Access Compliance Report

Public Rights-of-Way

(Curb Ramps)

Intersection ID: 16407	Main Street: PORTLAND_AV	Cross Street: PROVIDENCE_RD	Location: SW
ADA ID: D6312E34B67A	Ramp Type: BlendTrans1	Initial Pass/Fail: Fail	Overall Compliance: No
		Severity Score: 12.5

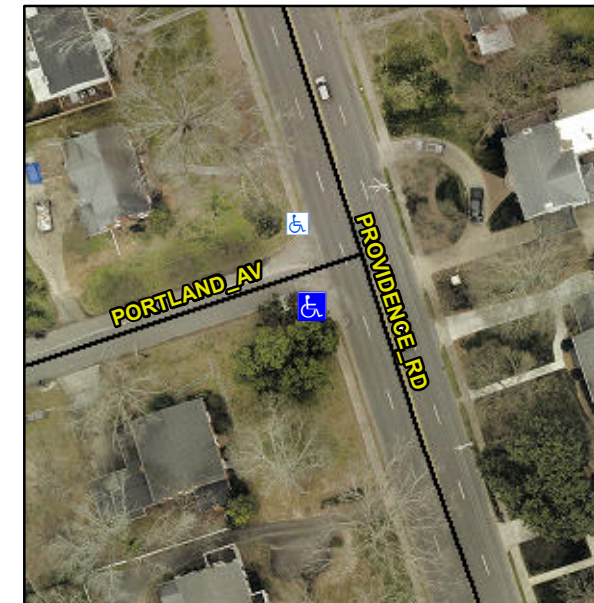
Not Found, R304.5.3

Compliance	Description	Data	Compliance	Description	Data
N/A	Ramp Length (in)	25.0	Yes	BlendTrans Slope (%)	4.7
Yes	Ramp Width (in)	48.0	No	BlendTrans XSlope (%)	6.1
N/A	Flare Type LT	N/A	N/A	Flare Type RT	N/A
N/A	Flare Slope LT (%)	N/A	N/A	Flare Slope RT (%)	N/A
N/A	Flare Traversable LT?	N/A	N/A	Flare Traversable RT?	N/A
N/A	Landing Length (in)	N/A	N/A	DWS Provided?	N/A
N/A	Landing Width (in)	N/A	N/A	DWS Contrast?	N/A
N/A	Landing Slope (%)	N/A	N/A	DWS Length (in)	N/A
N/A	Landing X Slope (%)	N/A	N/A	DWS Full Width?	N/A
N/A	Landing Curb? (Y/N)	N/A	N/A	DWS Offset (in)	N/A
N/A	Shared Landing?	N/A			
N/A	Gutter Ponding?	N/A	N/A	Gutter Slope (%)	N/A
N/A	Gutter Lip Ht (in)	N/A	N/A	Gutter X Slope (%)	N/A
N/A	Painted X Walk1?	No	N/A	Painted X Walk2?	No
	X Walk 1 Direction	To E		X Walk 2 Direction	To N
	X Walk 1 Width (in)	N/A		X Walk 2 Width (in)	N/A
	X Walk 1 Slope (%)	3.0		X Walk 2 Slope (%)	4.8
	X Walk 1 X Slope (%)	2.2		X Walk 2 X Slope (%)	1.2

N/A	Ramp inside XWalk1?	N/A	N/A	Ramp inside XWalk2?	N/A
	Road Slope (%)	5.1		Clear Space?	N/A
	Road X Slope (%)	3.2	N/A	Clear Space to XWalk (in)	N/A
N/A	Any Obstructions?	N/A	N/A	Storm Grate/Utility Hazard?	N/A
	Obstruction Type			Storm Grate/Utility Type	
		N/A			N/A
			Yes	Surface Condition? (G/P)	Good
			No	Curb Slope (%)	7.1

Remove & Replace Curb Ramp With Two New Directional Ramps or Equivalent.
